INFORMATIONAL MEMORANDUM

SUBJECT: Upcoming Development Agreements – Wadajir and Riverton Heights Mixed Use

Briefing on two development agreements that will be presented to the Council in early 2021. The two proposals are for “Wadajir” at 14110 Tukwila International Blvd (TIB) (L20-0034), and “Riverton Heights Mixed Use”, one block off of TIB at 144th Street and 37th Avenue S. (L19-0019).

Wadajir

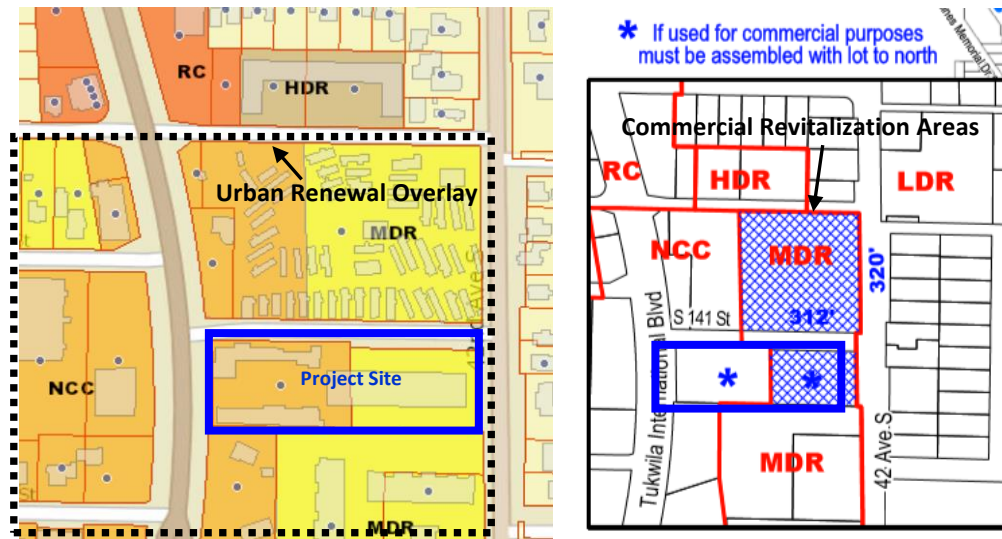
- A. Parking Stalls provided – is the reduced number and proposed arrangement (i.e., a combination of ground-level surface, on-site, and on-street parking) adequate for the proposed residential and commercial uses and acceptable to the neighborhood?
- B. Commercial Redevelopment Area requirements - requesting clarification of applicability and significance for development
- C. Recreation Space – can recreation space requirements on-site be reduced given the proximity of Cascade View Park to the project?
- D. The project site and building will need to comply with the TIB Design Guidelines.
